ADDENDUM #2

NORTH TRUCKEE DRAIN REALIGNMENT PHASE 1

BID #13/14-007 – PWP# WA-2014-011

This addendum is to notify all potential proposers of clarifications made to the Bid documents as stated below.

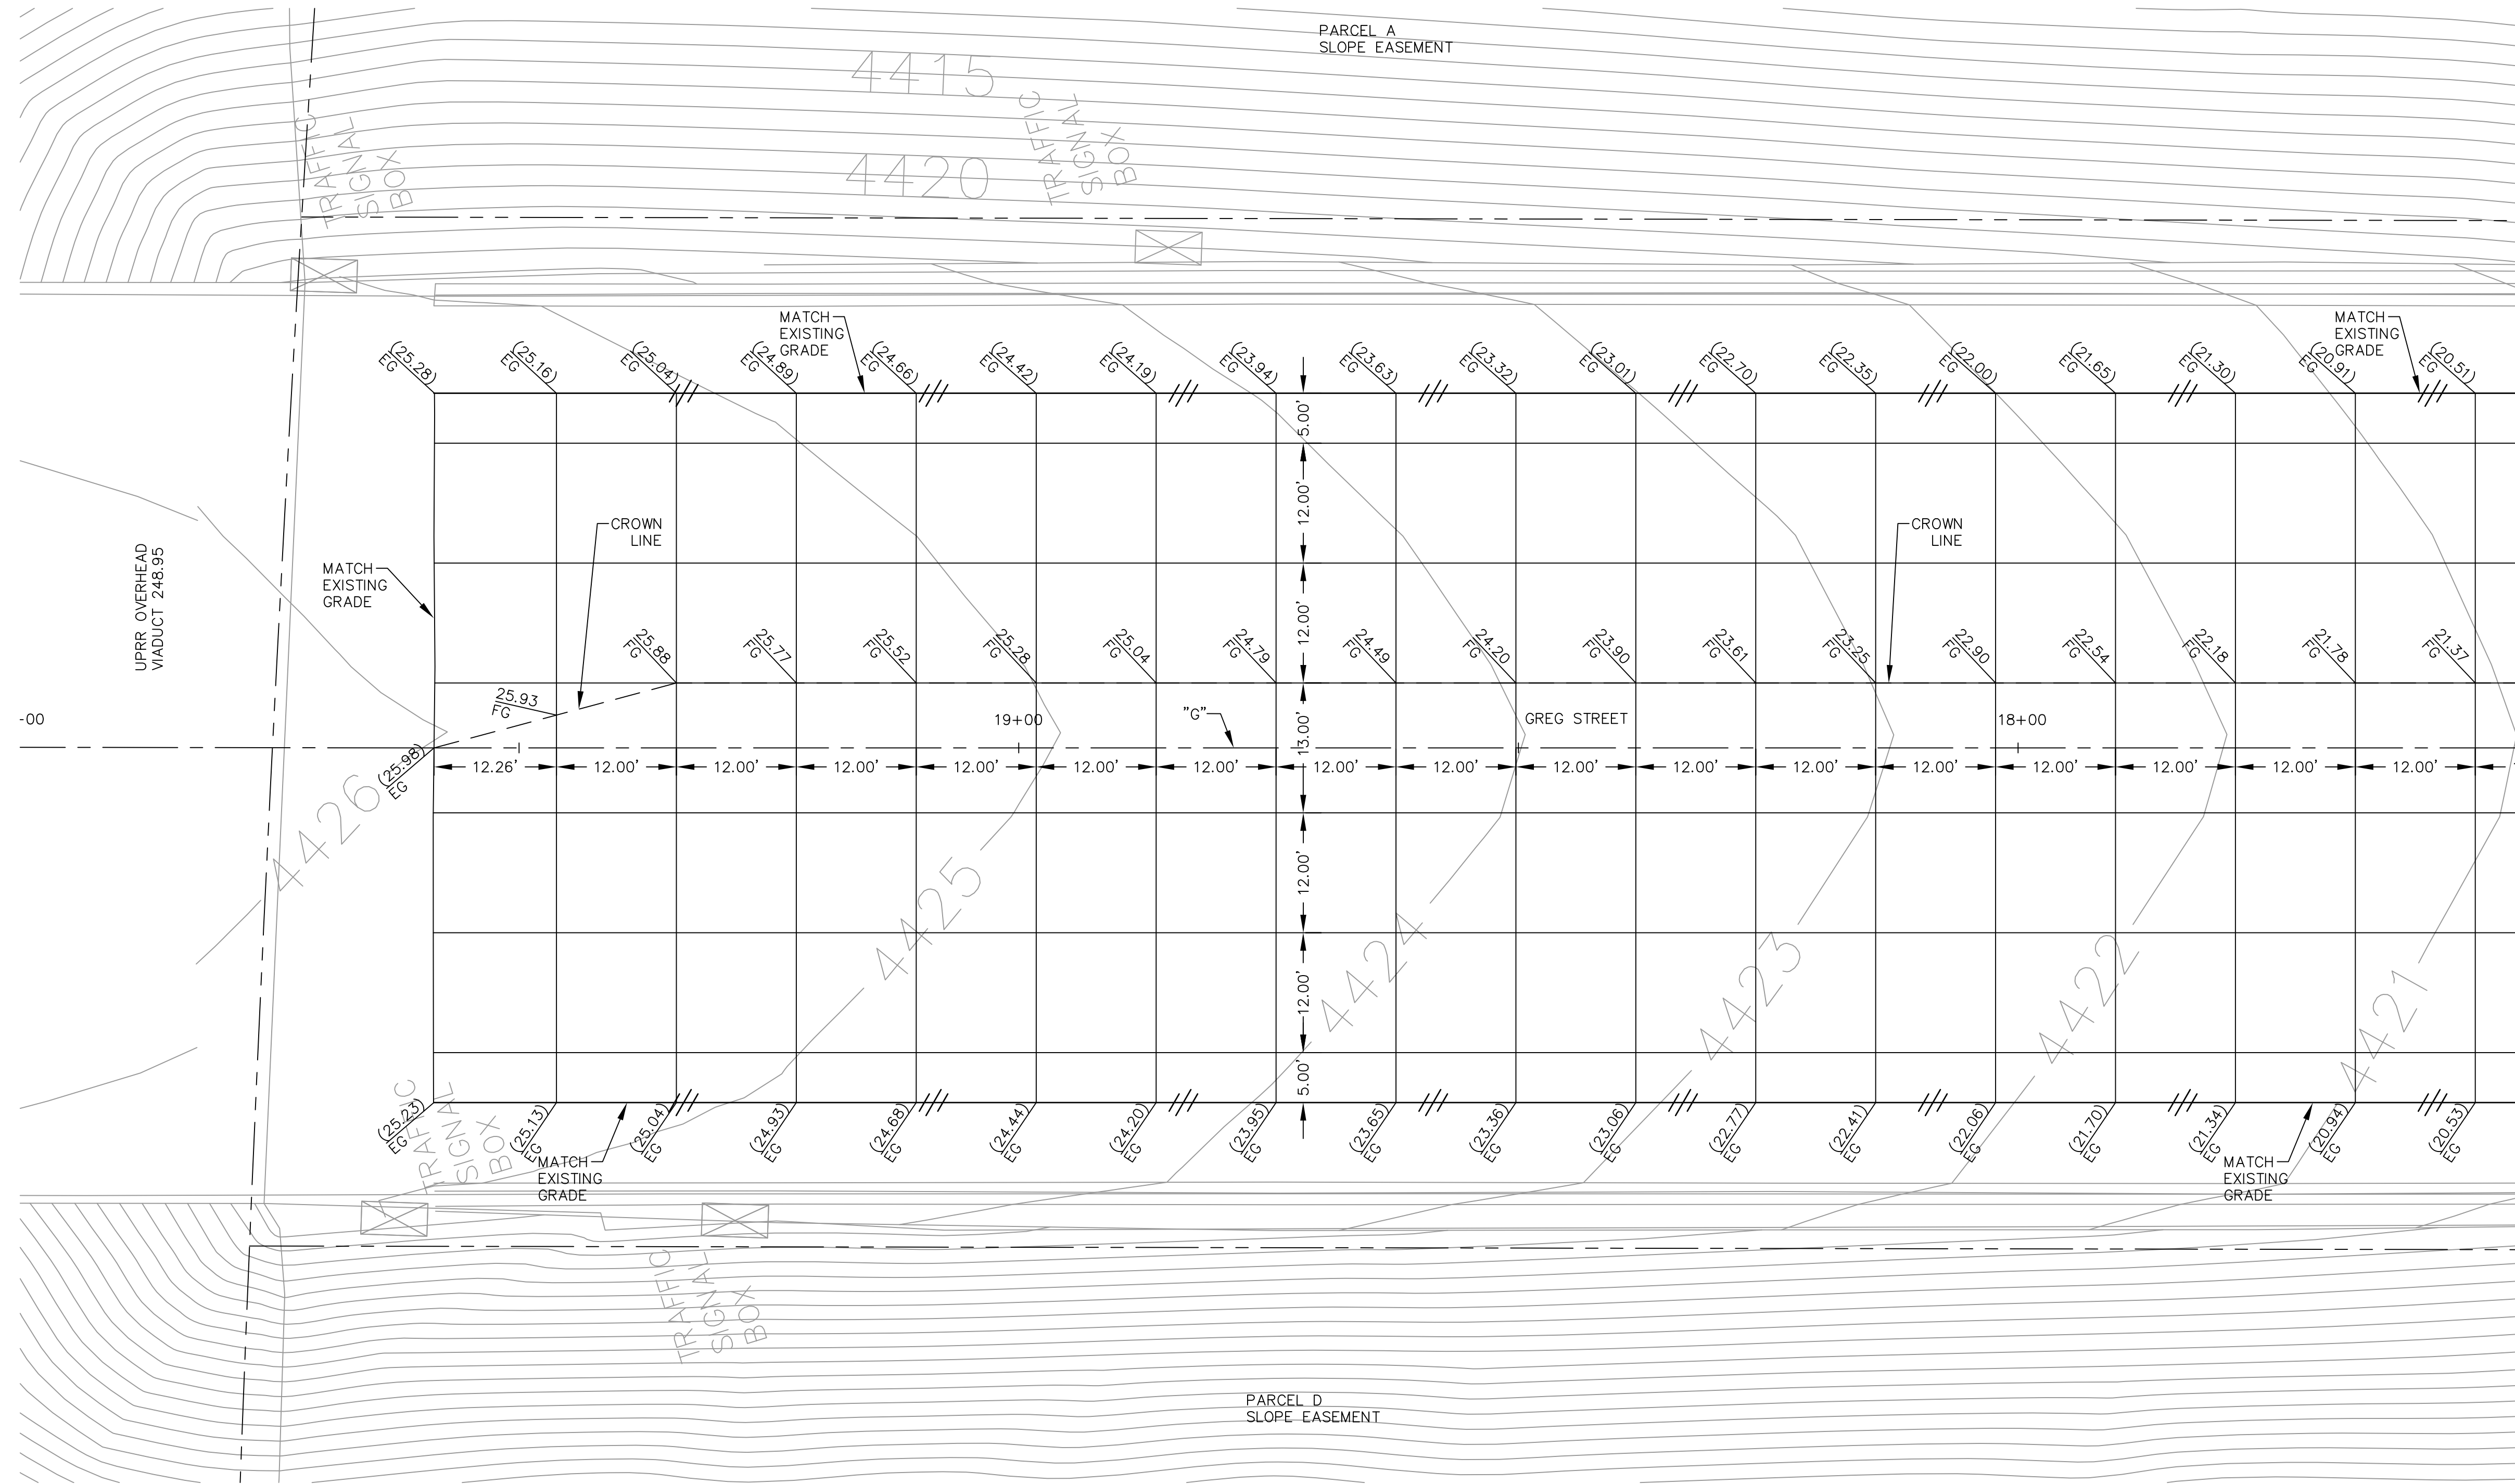
12. Sheet C-15 – Sheet was changed in its entirety.
13. Sheet ST-1 –
 - a. Notes and dimensions were changed throughout the sheet.
 - b. Note 11 was added.

SHEET NO. **ST-2**
SHT OF

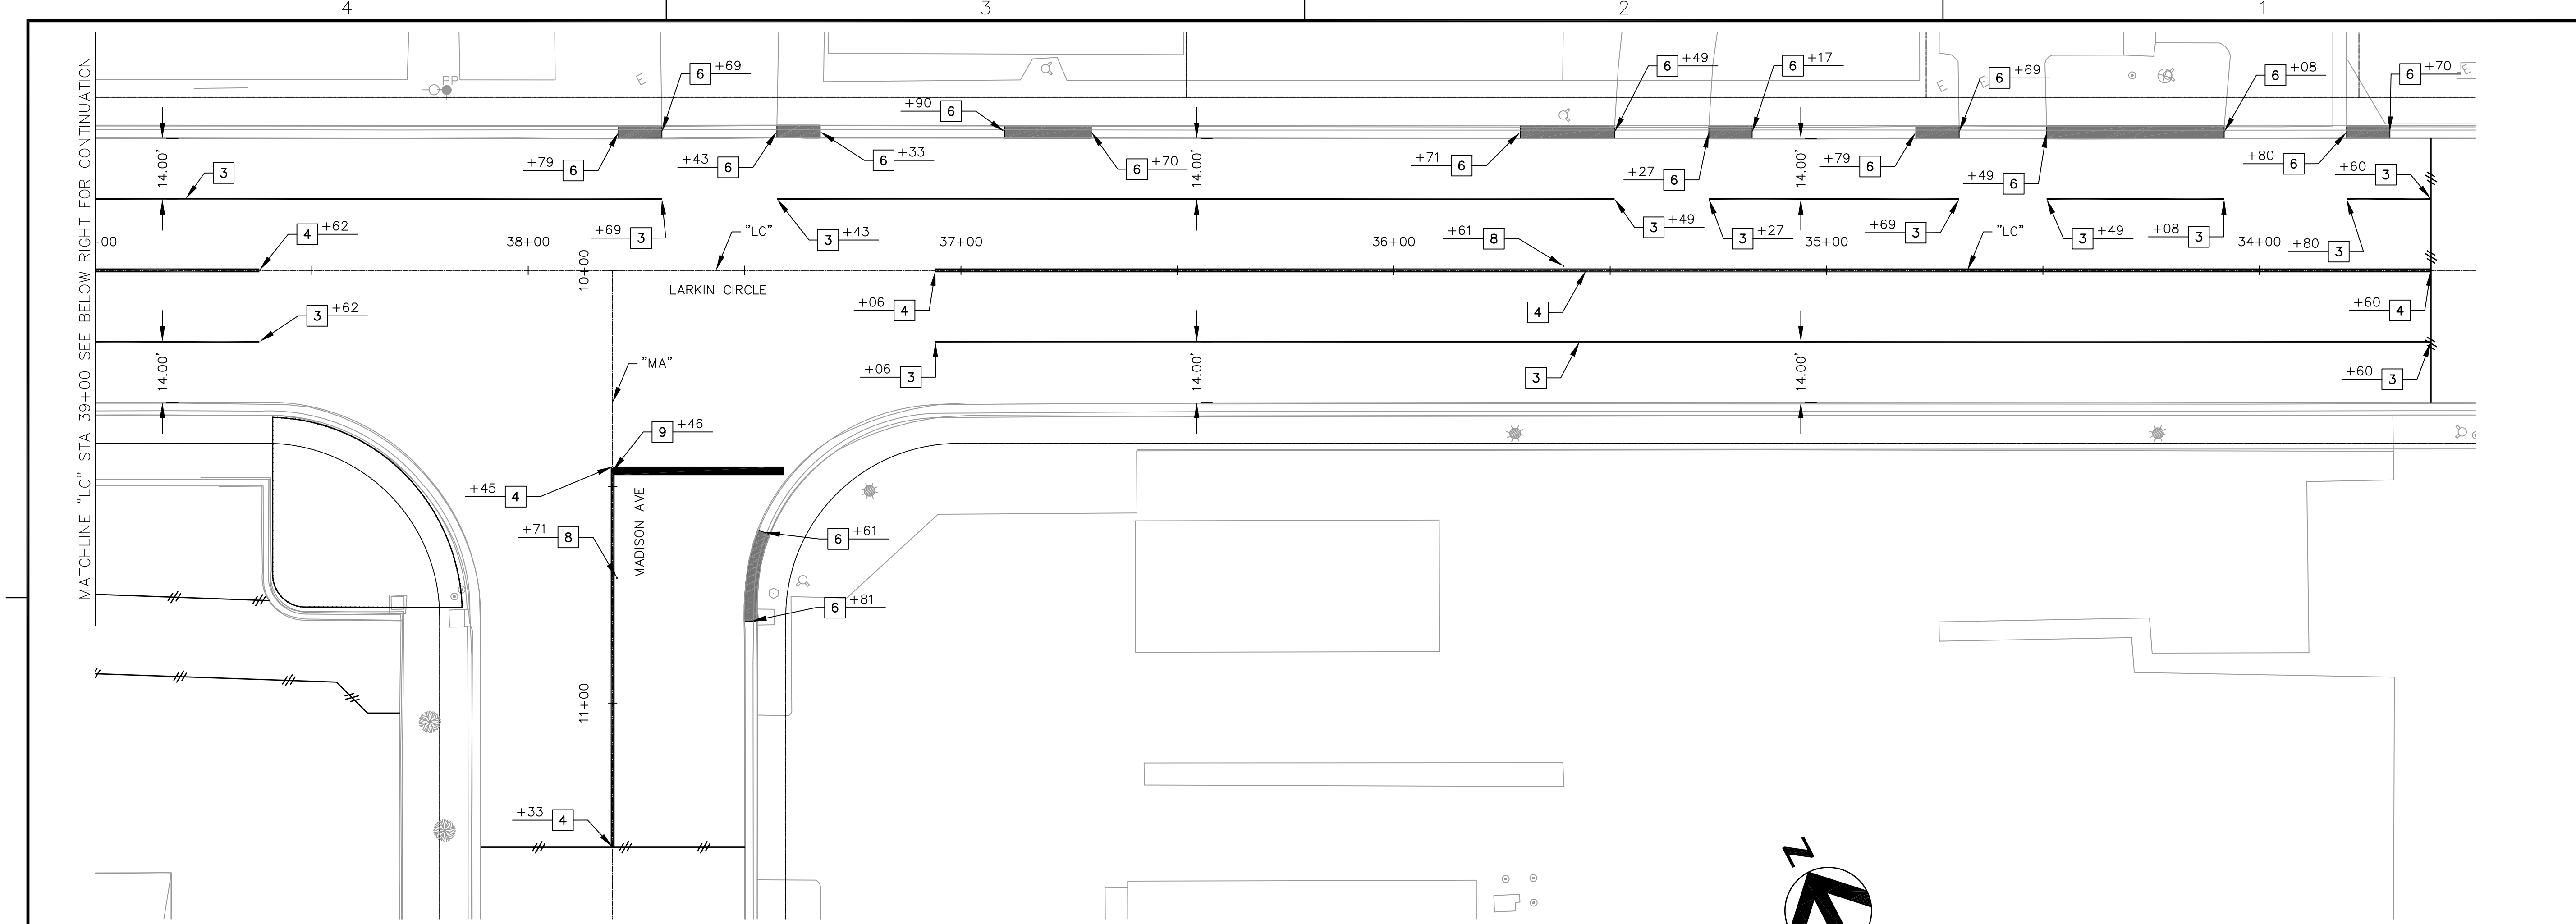
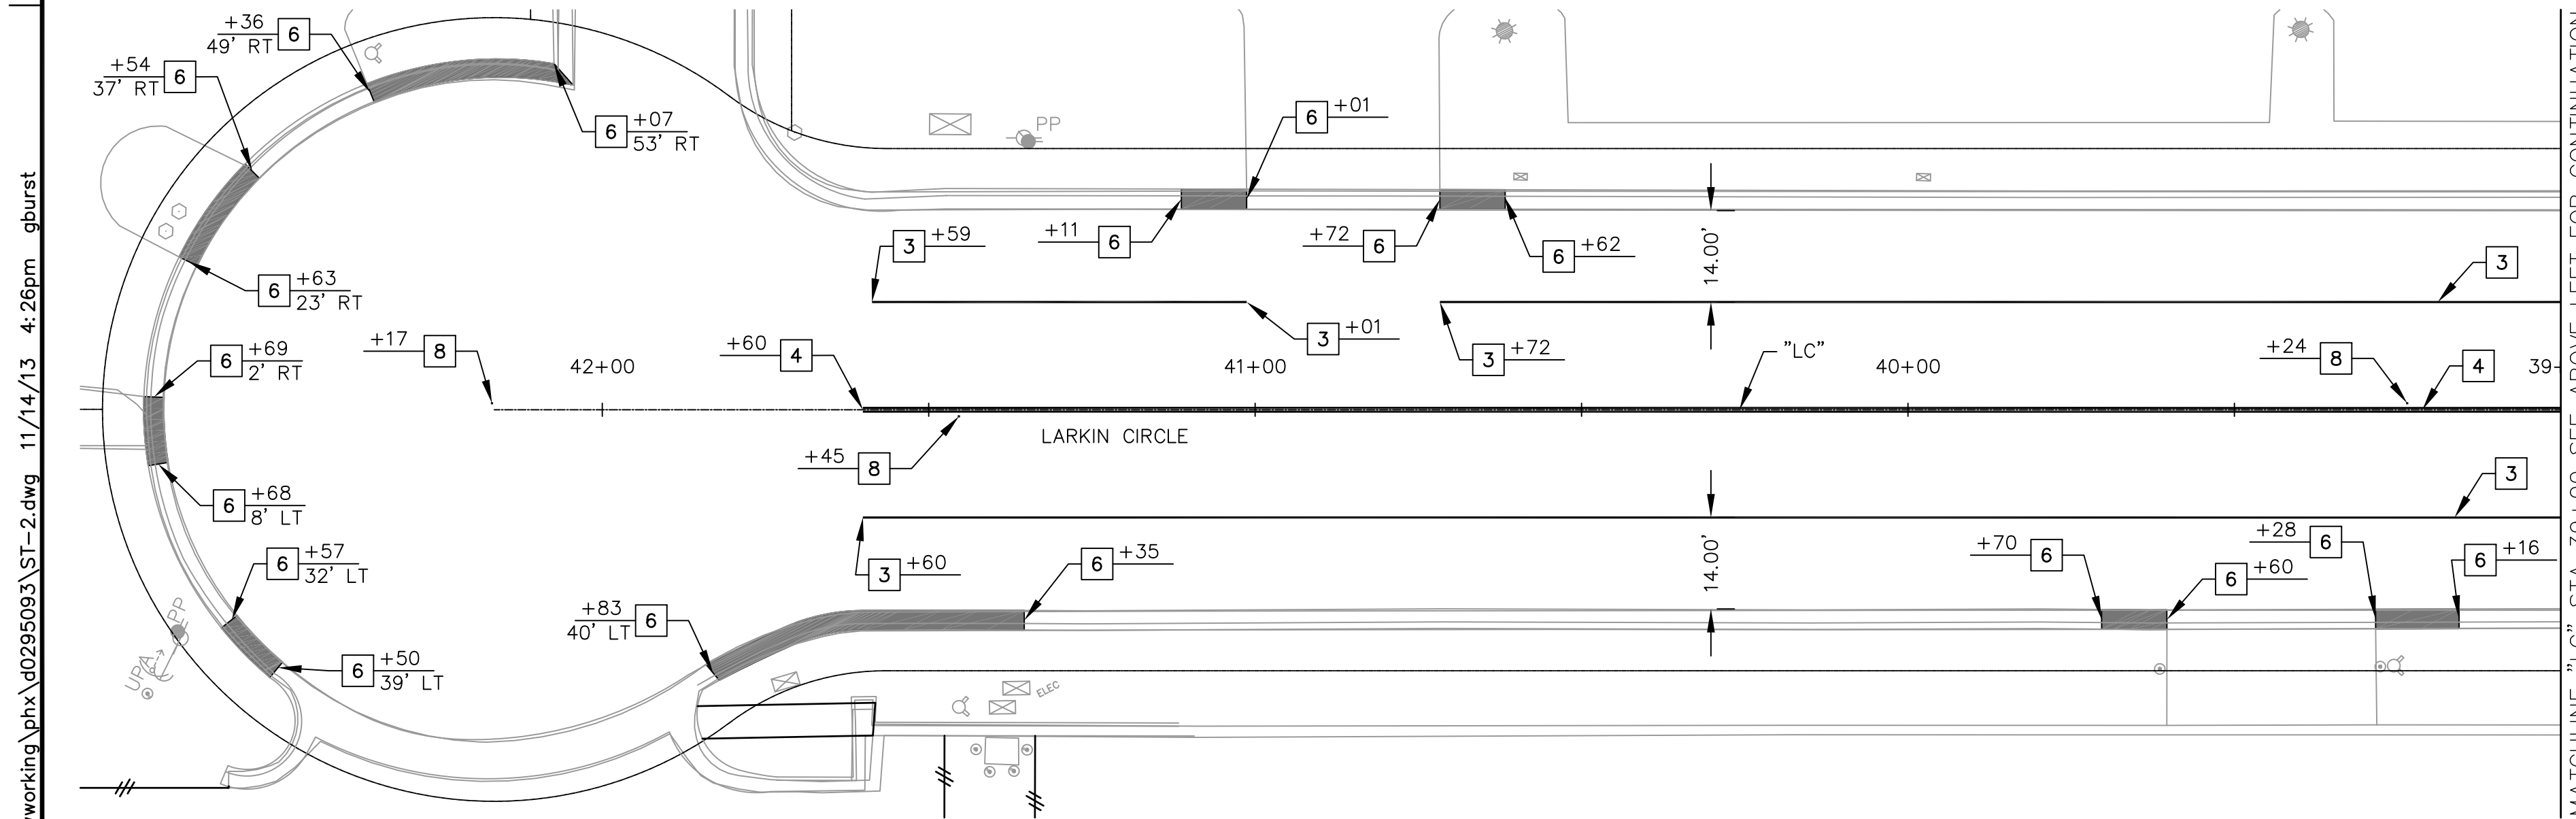
14. Sheet ST-2 – Note 11 was added
15. Sheet XS-1 – Remove the one "4" CTB" callout from the one drawing under the section titled: LARKIN CIRCLE – TYPICAL SECTION. Replace with the following note: "8" TYPE 2 CLASS B AGGREGATE BASE".
